Case No.: 3:22-cv-00175

**COMPLAINT FOR DECLARATORY AND
 INJUNCTIVE RELIEF FOR VIOLATIONS
 OF THE NATIONAL ENVIRONMENTAL
 POLICY ACT AND THE
 ADMINISTRATIVE PROCEDURE ACT**

- 18 3. The FHWA-CFLHD, in cooperation with the USDA, LTBMU, NDOT, and TRPA, is undertaking
 19 a project to relocate the current RHP entrance/exit approximately 0.2 miles (1,056 feet) north from
 20 the existing entrance/exit road (the “RHP Project”). The FHWA-CFLHD claims the RHP Project
 21 is needed “because the current US 50 entrance configuration into [RHP] has safety concerns due
 22 to limited sight distance for vehicles traveling in both directions along US 50 and unprotected
 23 turning movements across US 50,” *See*, FONSI, Appendix F, Purpose and Need Statement.
 24 Construction on the RHP Project has not yet commenced.

- US 50 Signing and Pavement Markings plan sheet

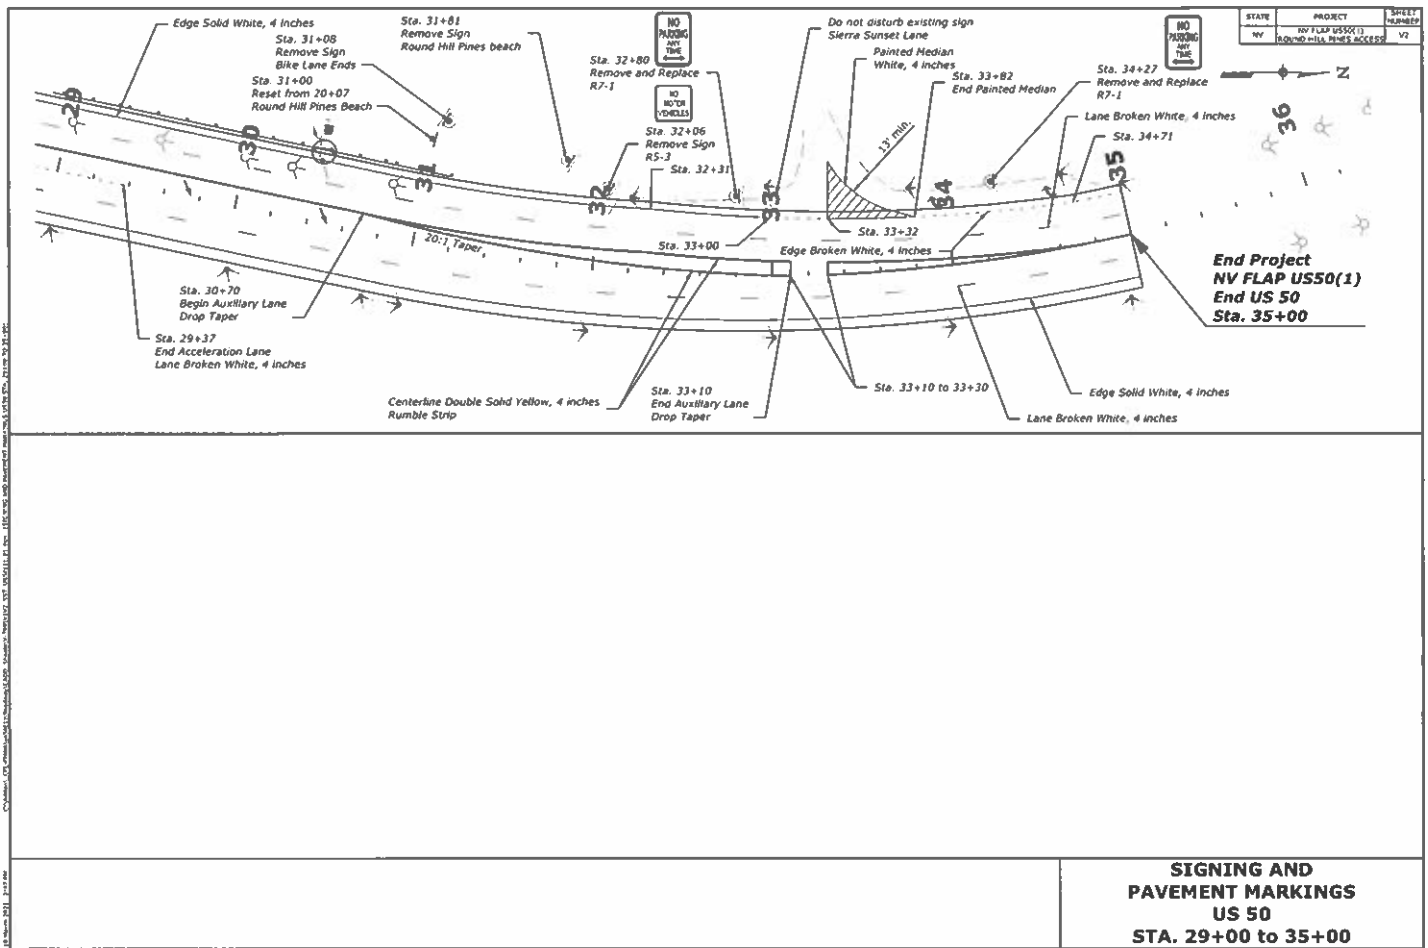
Appendix 'G' to Appendix 'B' – US 50 Signing and Pavement Markings plan sheet V2 (386-387/464.pdf) primarily shows the left turn refuge and accel lane for RHP again at Freeway design standards, with no left turn refuge for Sierra Sunset Lane; this design has been discussed elsewhere in the FONSI text. So, when the designer redesigns US 50 to the proper Highway standards for the Highway Functional Class, rather than the improper Freeway Functional Class, the designer creates a great safety improvement opportunity for all concerned. There will be enough safe space for the RHP left turn lane (that can stay the same as designed) in conjunction with a properly designed and therefore shortened accel lane. While still providing proper safe design standards for RHP, the additional increased safety for all vehicles will be obtained by providing a safe space for all vehicles passing and turning at Sierra Sunset Lane by providing its own separated left turn refuge lane. Unless this re-design is undertaken, the project is ACTUALLY making a very slightly substandard design worse – therefore, 'de-designing' Sierra Sunset Lane – to the supposed benefit of the project for RHP's proposed access. Any unsafe aspects of the access to/from Sierra Sunset Lane in the proposed projects are also potentially unsafe for users of RHP. If a tragic accident were to happen to someone trying to enter/exit Sierra Sunset Lane, then it is likely that someone trying to enter/exit RHP would also be involved.
